# UNITED STATES PATENT AND TRADEMARK OFFICE

APPLICATION NO.	FILING DATE	FIRST NAMED INVENTOR	ATTORNEY DOCKET NO.	CONFIRMATION NO.
10/599,491	09/29/2006	Carlo Innocenti	891,021	9745
24106 7590 03/08/2010 EGBERT LAW OFFICES 412 MAIN STREET, 7TH FLOOR HOUSTON, TX 77002				
EXAMINER				
COLILLA, DANIEL JAMES				
ART UNIT		PAPER NUMBER		
2854				
MAIL DATE		DELIVERY MODE		
03/08/2010		PAPER

### Office Action Summary

## **DETAILED ACTION**

Fig. 3

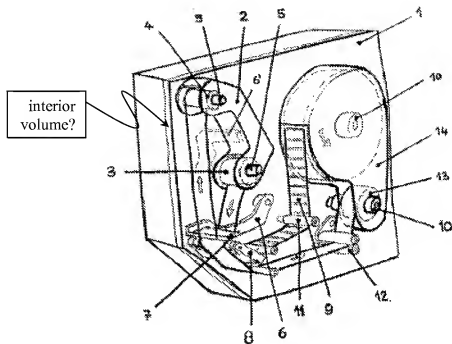
2. With respect to the objection to the drawings applicant state that the structure indicated by reference numeral "1" is an "enclosing structure" as recited in claim 1. However, as shown below in the Figure taken from applicant's drawings, reference numeral 1 appears to indicate a base upon which the printing structure is mounted:

If applicant is referring to the line which appears to go around the top of the mounting structure as the enclosing structure, this is not clearly shown in the drawings. Furthermore, this structure does not appear to enclose the printing structure as recited in the claim.

3. The drawings are objected to under 37 CFR 1.83(a). The drawings must show every feature of the invention specified in the claims. Therefore, the “**enclosing structure**” as recited in claim 5 must be shown or the feature(s) canceled from the claim(s). No new matter should be entered.

Corrected drawing sheets in compliance with 37 CFR 1.121(d) are required in reply to the Office action to avoid abandonment of the application. Any amended replacement drawing sheet should include all of the figures appearing on the immediate prior version of the sheet, even if only one figure is being amended. The figure or figure number of an amended drawing should not be labeled as "amended." If a drawing figure is to be canceled, the appropriate figure must be removed from the replacement sheet, and where necessary, the remaining figures must be renumbered and appropriate changes made to the brief description of the several views of the drawings for consistency. Additional replacement sheets may be necessary to show the renumbering of the remaining figures. Each drawing sheet submitted after the filing date of an application must be labeled in the top margin as either "Replacement Sheet" or "New Sheet" pursuant to 37 CFR 1.121(d). If the changes are not accepted by the examiner, the applicant will be notified and informed of any required corrective action in the next Office action. The objection to the drawings will not be held in abeyance.

**FIG.12**

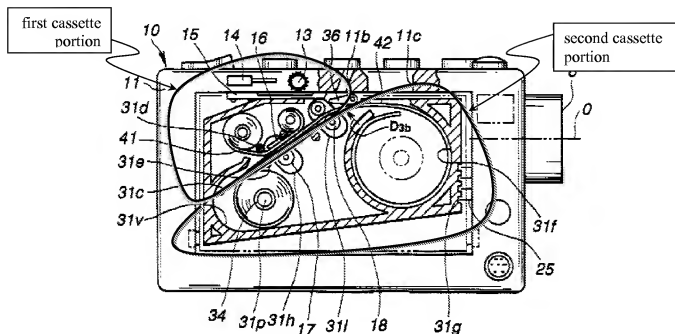
Nagasaki *et al.* discloses a thermal transfer printer apparatus comprising: an enclosing structure 11 having an interior volume; a thermal printhead 16 positioned in said enclosing structure 11; a first cassette portion positioned in said interior volume of said enclosing structure as shown below in the figure taken from Fig. 12 of Nagasaki *et al.*:

Nagasaki *et al.* further discloses said first cassette having a take-up core 33 and a spool 22 of printing ribbon 41 (also known as ink ribbon) therein (as shown in Fig. 3 of Nagasaki *et al.*), said first cassette having a first hole corresponding to said spool of printing ribbon and a second hole corresponding to said take-up core of printing ribbon (although Nagasaki *et al.* does not depict them, these holes are inherent so that the first cassette portion can receiving driving shafts 21 and 22 for feeding the printing ribbon as shown in Fig. 4 of Nagasaki *et al.*);

a second cassette portion (as shown above) of an asymmetrical configuration positioned in said interior volume of said enclosing structure, said second cassette having a spool 34 of a
